## Supplement to Exhibit No. 19(e)

Subject: RE: Correspondence from Bowman Wind

Map of greater sage-grouse overlap with proposed wind farm in Bowman County, North Dakota. Shown are leks occupied in the last 5 years and last 10 years and the Sage-grouse primary nesting range.

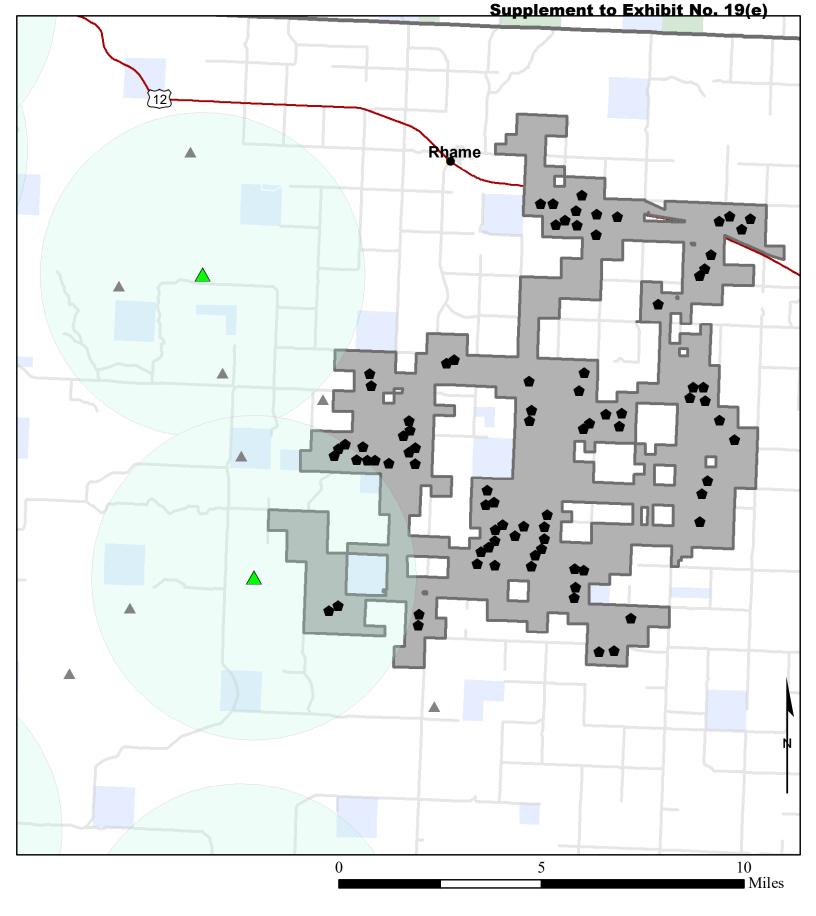
Question 1: The attached map shows Lek B6 and the turbines that fall within the buffer. The spatial data is also attached.

Question 3: Turbines 45, 46, 48, 71, 73, and 41 all fall within 4 miles of Lek B6. This lek was last occupied in 2021.

Question 4: Turbines 41 and 45 both fall within the Priority Conservation Area (PCA).
